# ADDENDUM No. 1

## RFP No. 24-10

### 2024 Miscellaneous Utilities Project

**CITY OF ANN ARBOR - PUBLIC SERVICES - ENGINEERING**  
**ANN ARBOR RAILROAD / BOARDWALK CULVERT IMPROVEMENTS PROJECT**

SHEET No. 8 OF 9

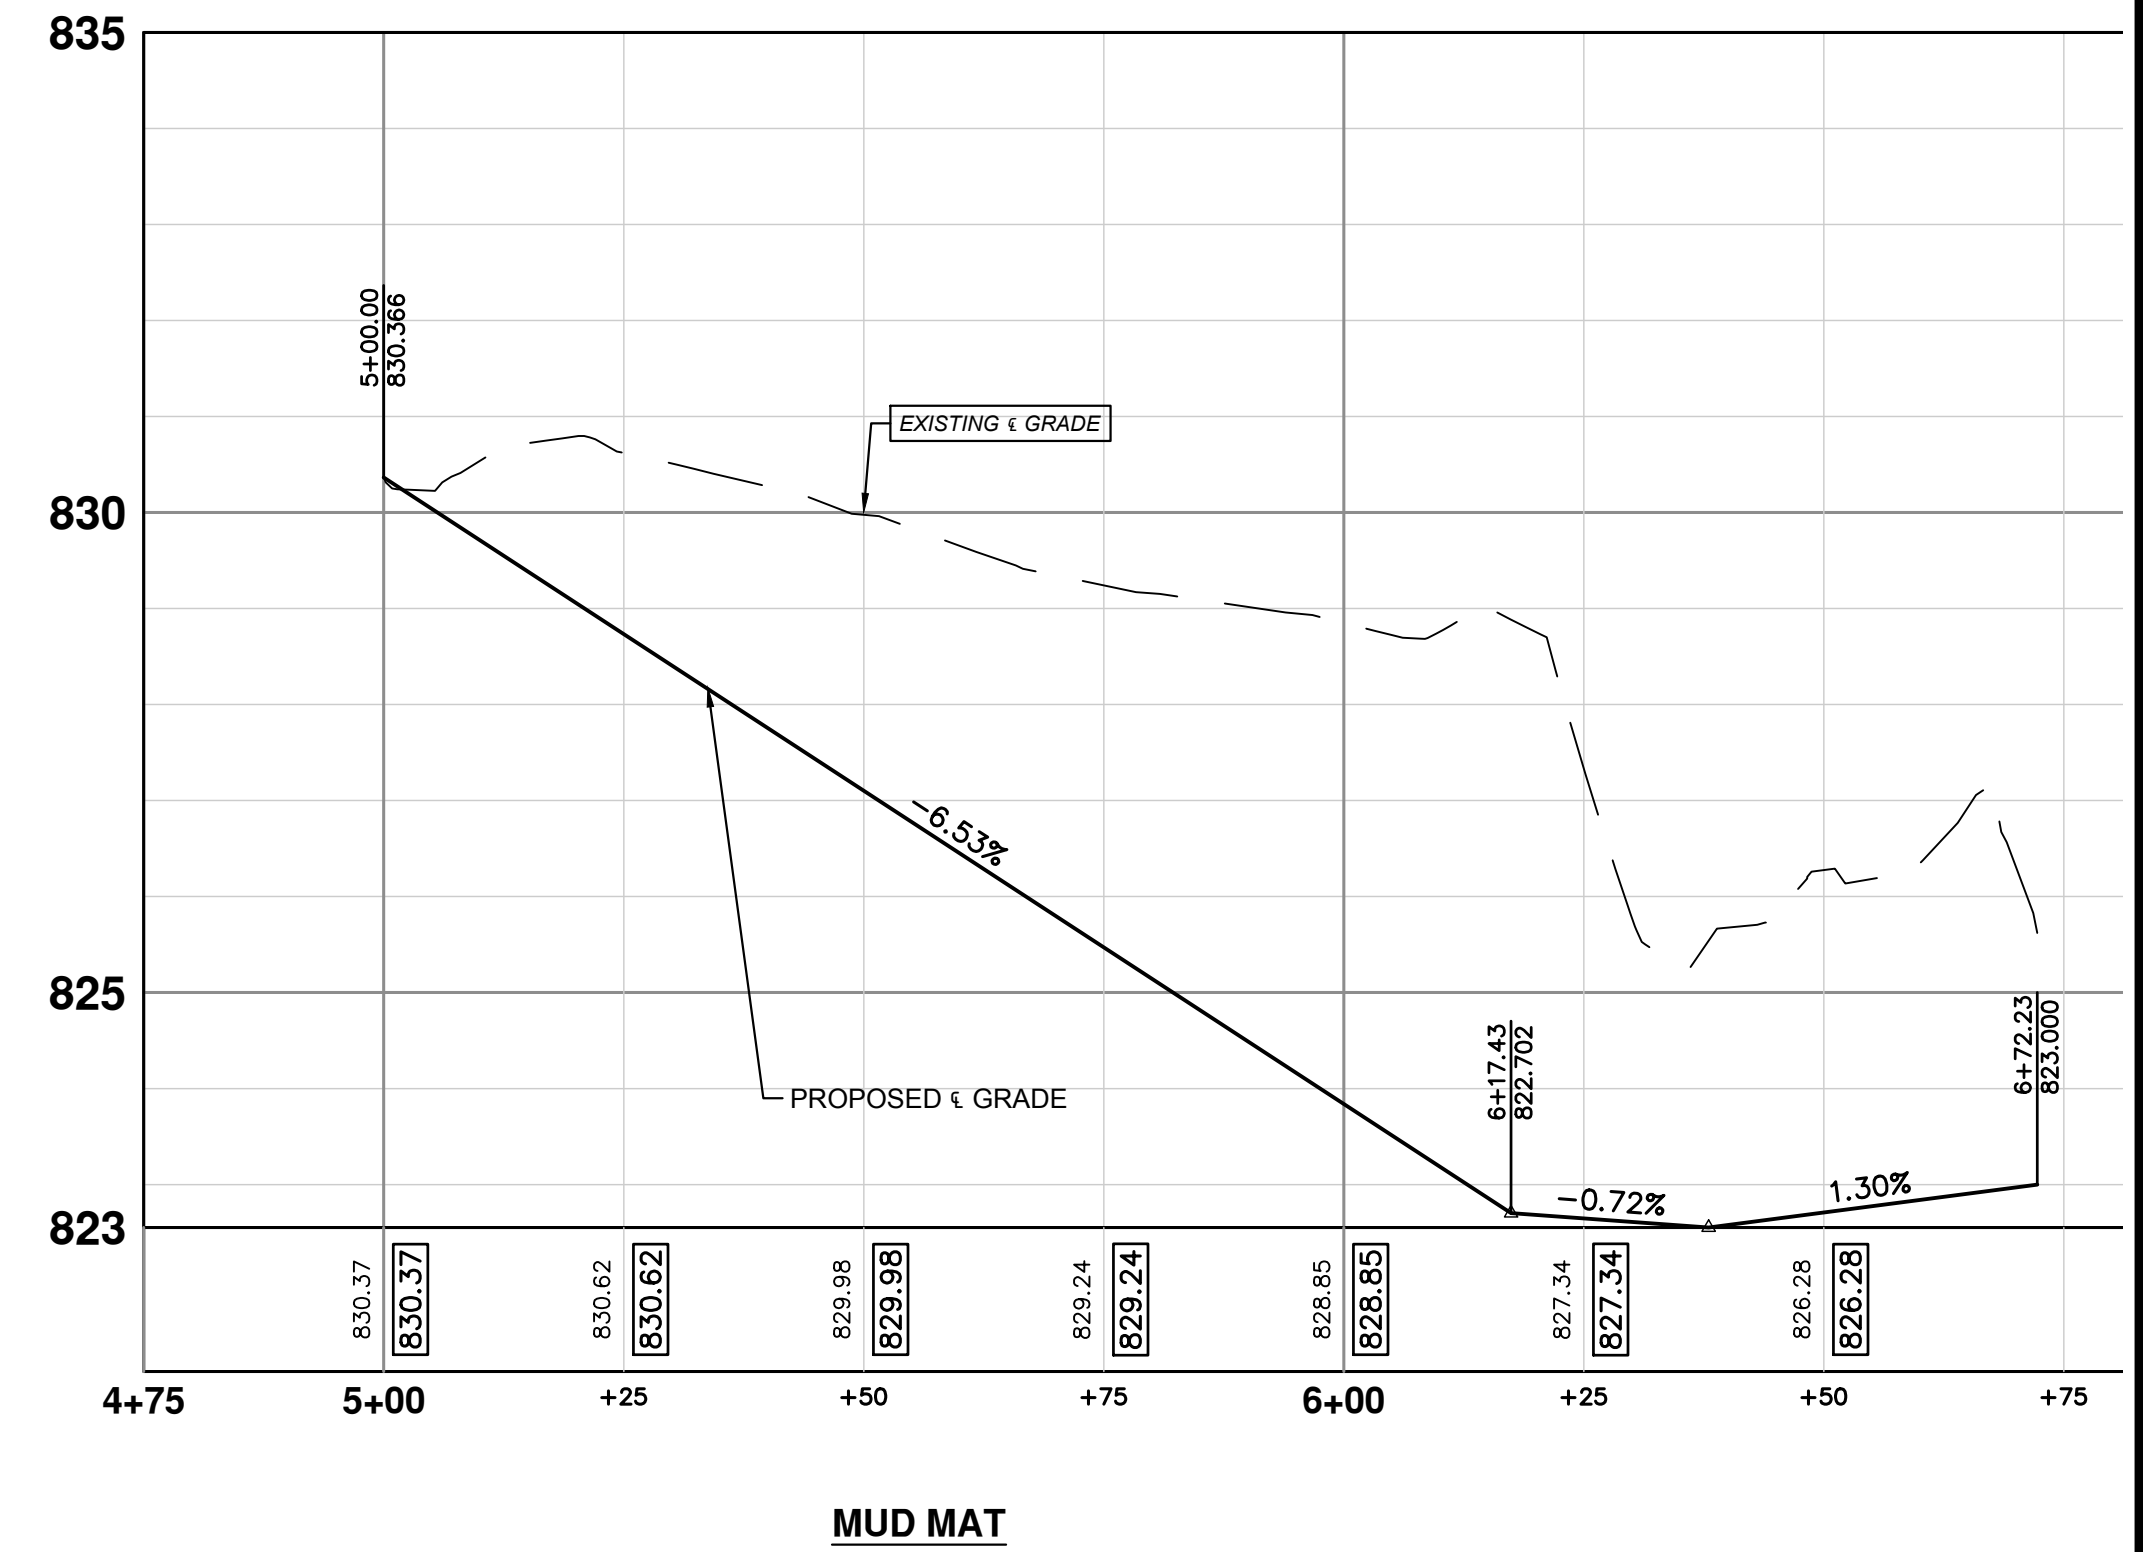
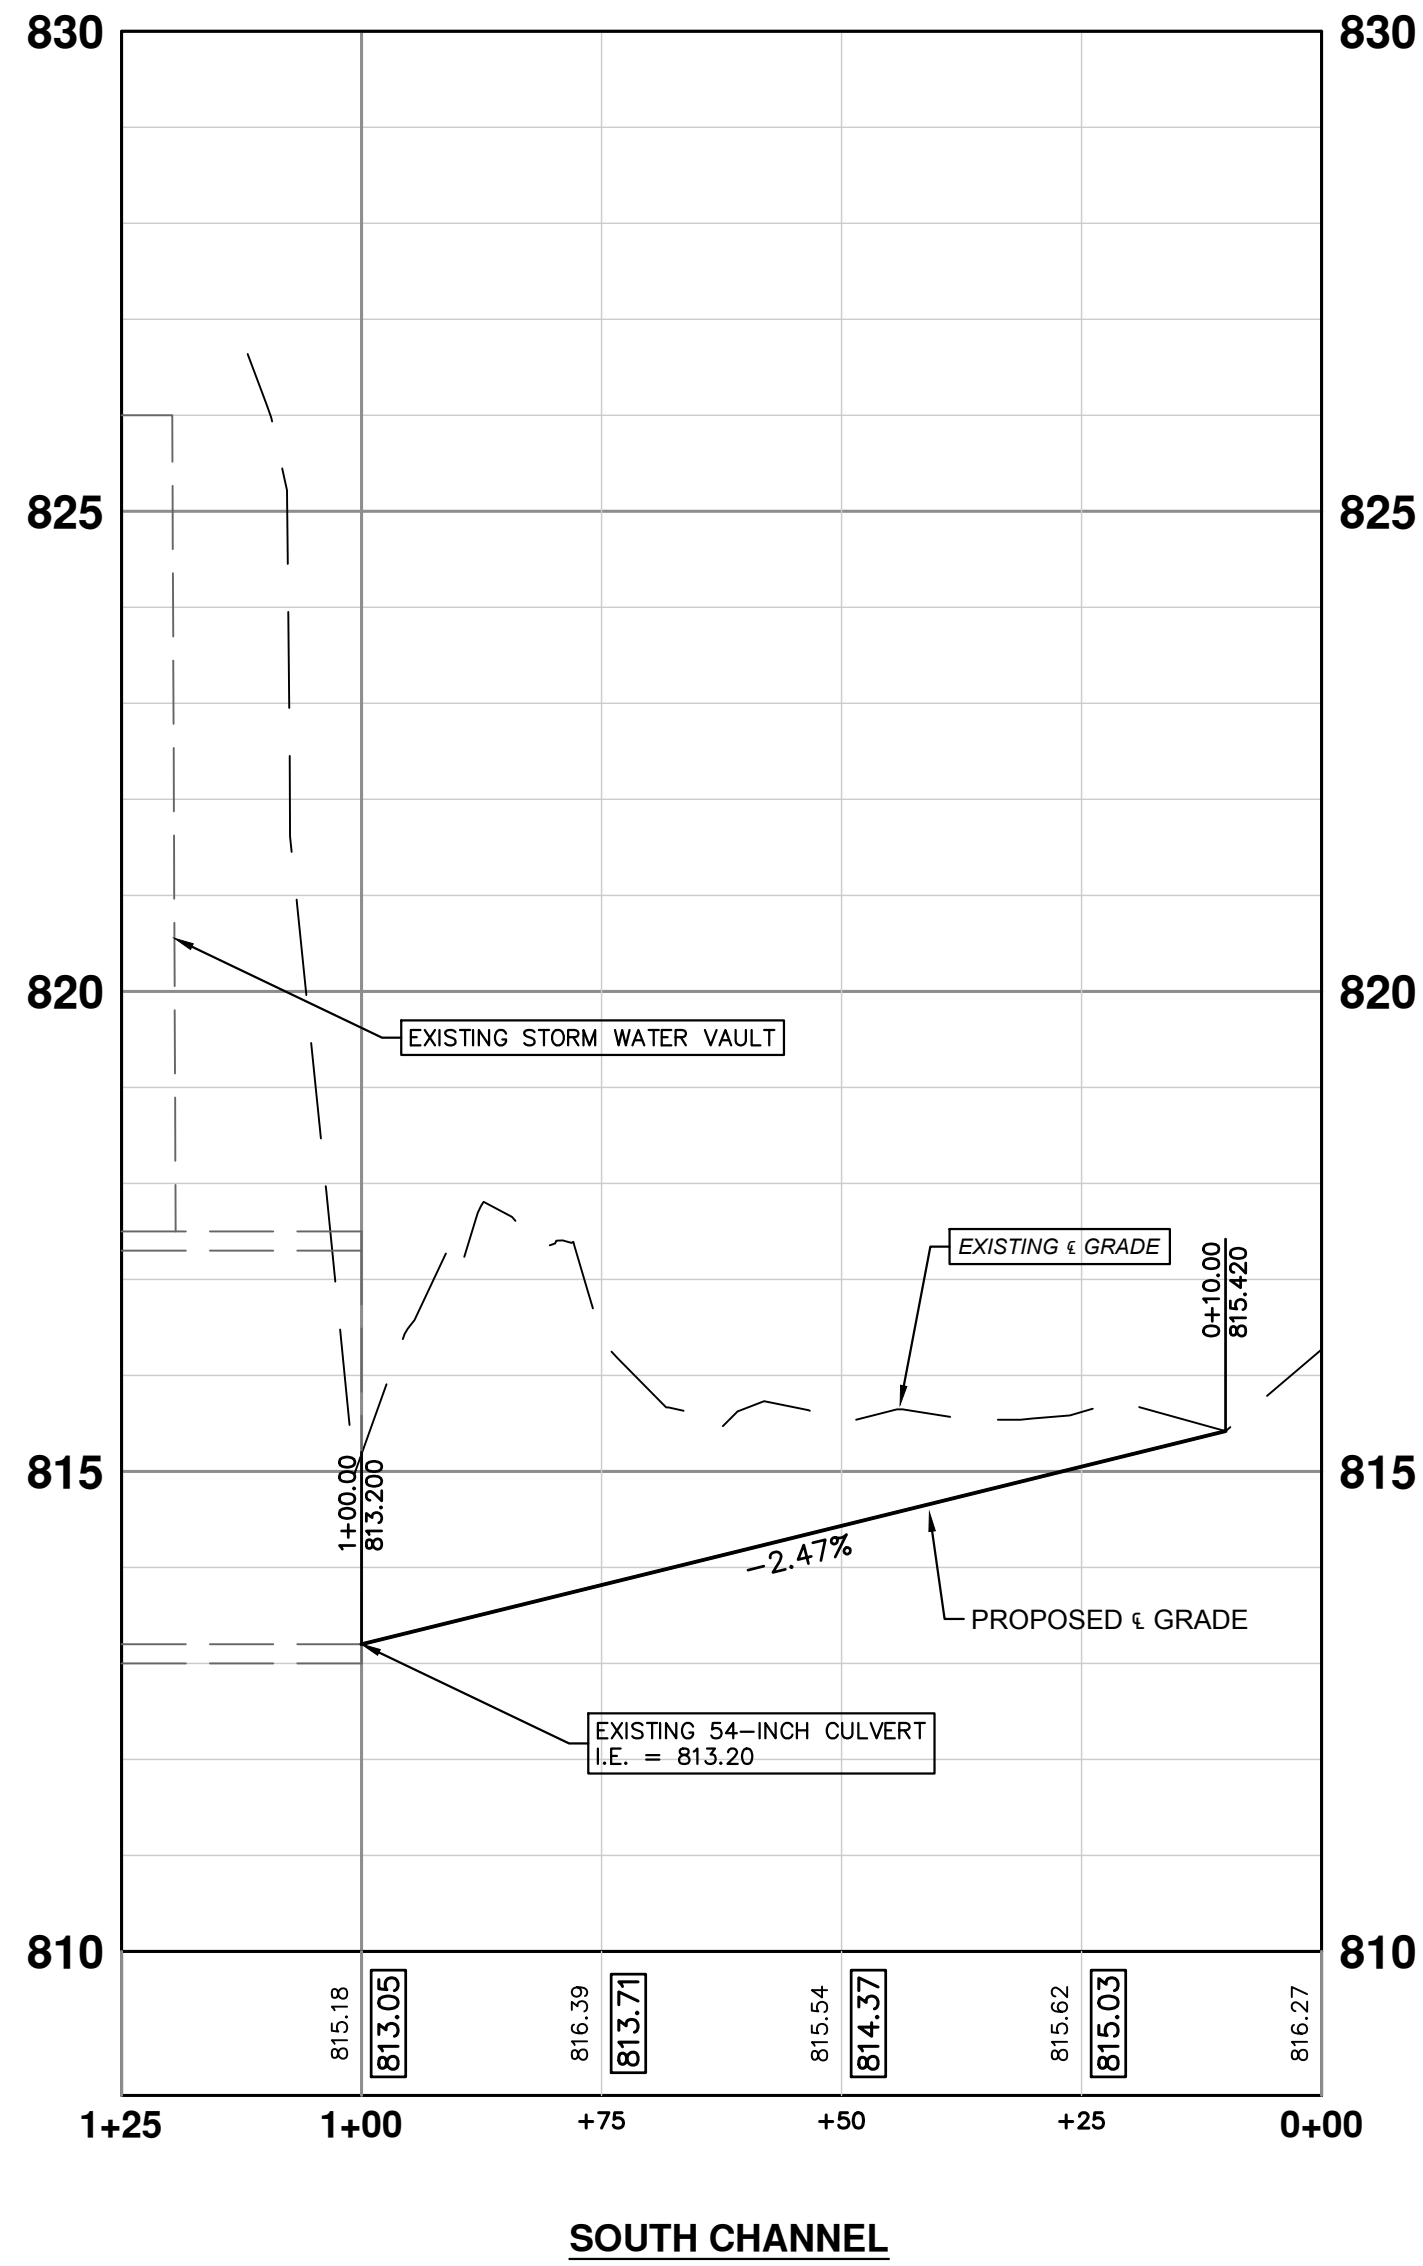
Sheet 8 of 9  
Channel Profiles

Profiles updated

NOTE: MUD MAT IS A PROPOSED ACCESS PATHWAY TO THE 90-INCH STORM SEWER REMOVAL AND REPLACEMENT. REMOVAL OF THE EARTH ASSOCIATED WITH THE PIPE REMOVAL WILL BE INCLUDED IN THAT REMOVAL PAY ITEM WHILE REMOVAL OF EARTH FOR THE MUD MAT INSTALLATION WILL UTILIZE MACHINE GRADING, MODIFIED
